Conceptual Review Agenda

Schedule for 04/08/13 to 04/08/13

Re: 1800 Harmony - Baseball Training Facility

Description of project: This is a request for an Addition of a Permitted Use for Unlimited Indoor Recreation in the Harmony Corridor zone to use a portion of an existing warehouse as a baseball training facility located at 1800 East Harmony Road (Parcel # 87314-00-033). An Addition of a Permitted Use must be accompanied by a Project Development Plan, or an Amendment to an approved plan and is subject to Planning & Zoning Board (Type 2) review.

CONCEPT
SITE PLAN

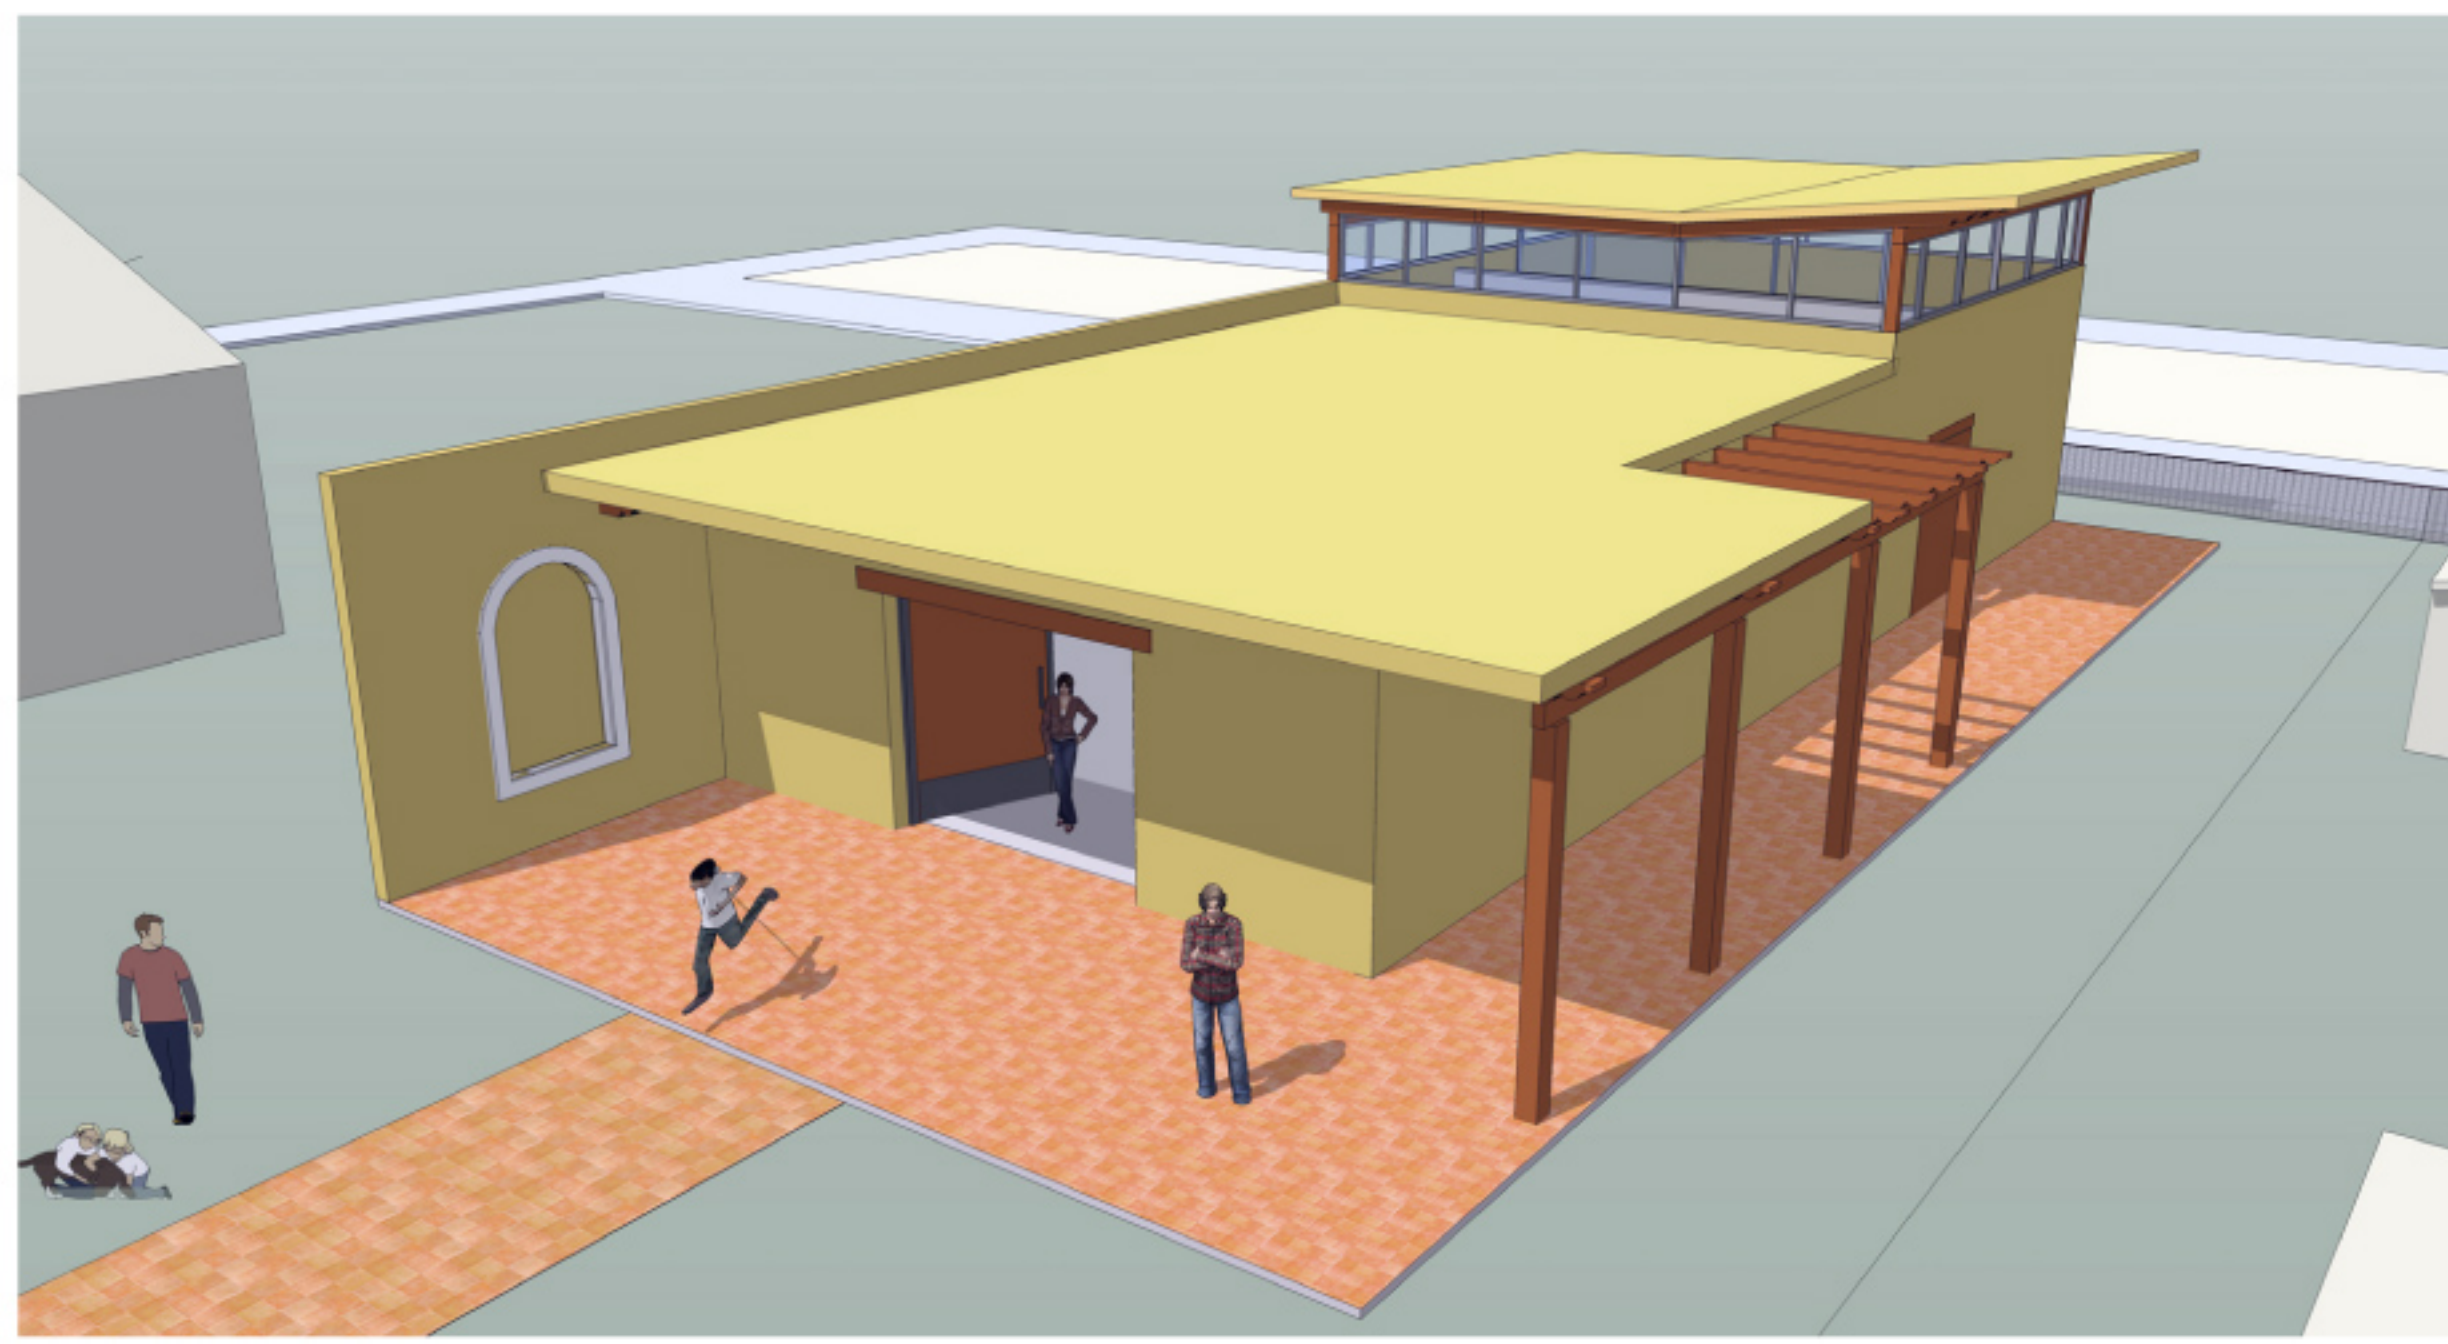
4. Please call out setback dimensions from the property lines to the proposed interpretive center on the site plan.
5. Your site plan should include the properties to the north and south (with building footprint) as well as show the alley. On the elevations, please have an exhibit that shows the streetscape - the Museo, the proposed building, then the residence to the south. This will help staff assess compliance with Section 3.5.1 of the Land Use Code (compatibility) as well as 3.4.7 (Historic Resource compatibility).
